SUBJECT: **NEW VEHICLE DEMONSTRATION / DELIVERY HOLD – Customer Satisfaction Program 17B25 – *Supplement #1***
 Certain 2013-2017 Model Year Police Interceptor Utility Vehicles
 Exhaust Odor and Carbon Monoxide Complaints

New! REASON FOR THIS SUPPLEMENT

- *Updated Service Action and Technical Information Attachment III, to include sealing certain floor pan body plugs with foil-backed mastic patches*
- *Updated Labor Allowances and Parts Requirements*
- *Updated Dealer Q & A*

FIGURE 31

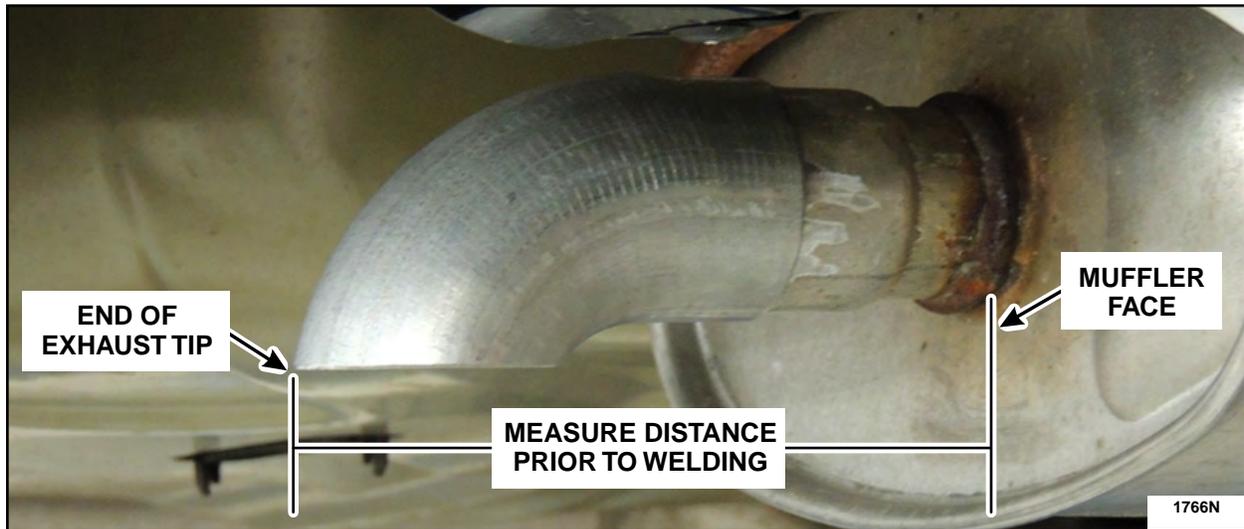
3. Install the *new* exhaust tips. Use a tape measure or ruler to position the exhaust tip prior to welding. See Figure 31.

- 2013-2015 vehicles with 3.5L GTDI engine 7 5/8 in (193 mm).
- 2016-2017 vehicles with 3.5L GTDI engine 8 1/16 in (206 mm).
- All vehicles with 3.7L engine 6 7/8 in (174 mm).

FIGURE 33

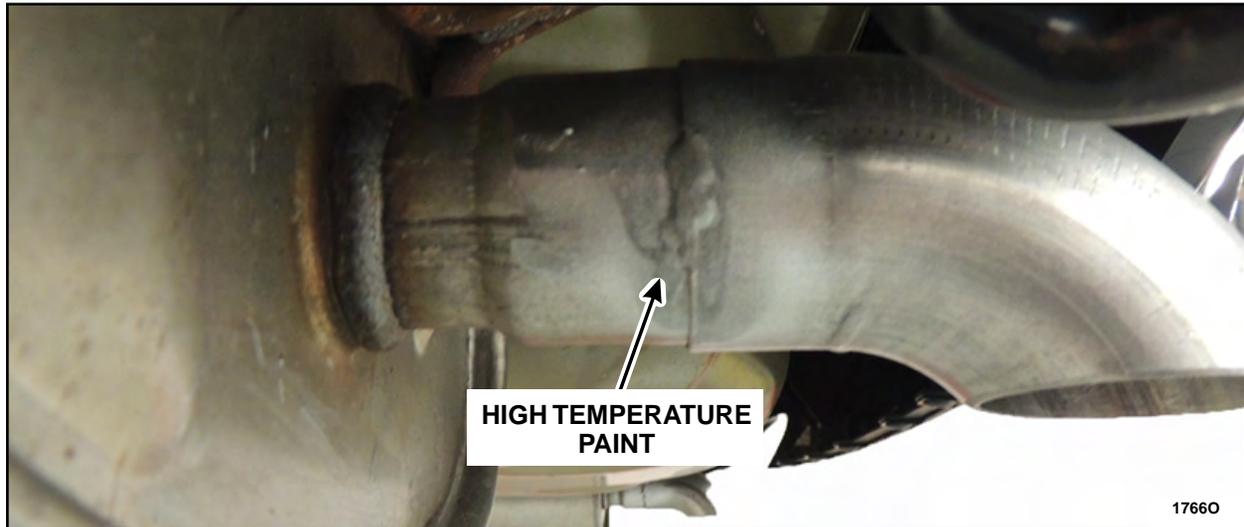
5. Apply 1 in (25 mm) long weld beads along both sides of each exhaust tip using 308L or 409SS MIG welding wire. See Figure 33.

NOTE: If tips are welded using wire other than 308L or 409SS MIG welding wire, the welds must be protected from corrosion with two coats of high-temperature exterior paint rated at 500°F (260°C) or higher.

FIGURE 34

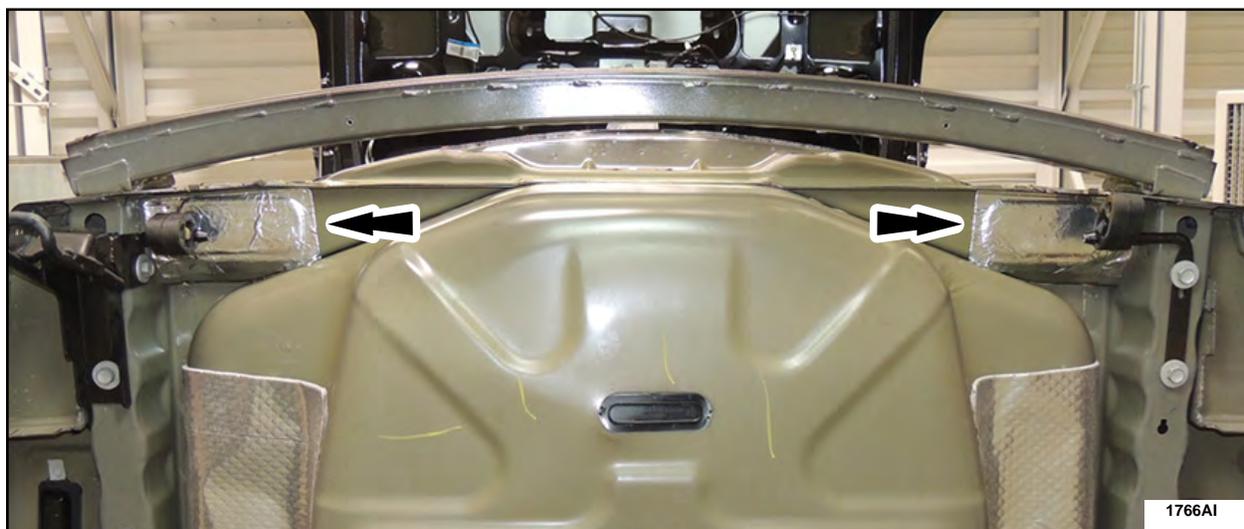
6. Clean the body plugs and surrounding sheet metal, then apply the mastic patches to the underbody plugs as shown in Figure 34.

NOTE: Make sure each patch completely covers the body plug.

NOTE: Apply firm pressure when applying the mastic patch to the underbody plugs and surrounding sheet metal to ensure proper adhesion.
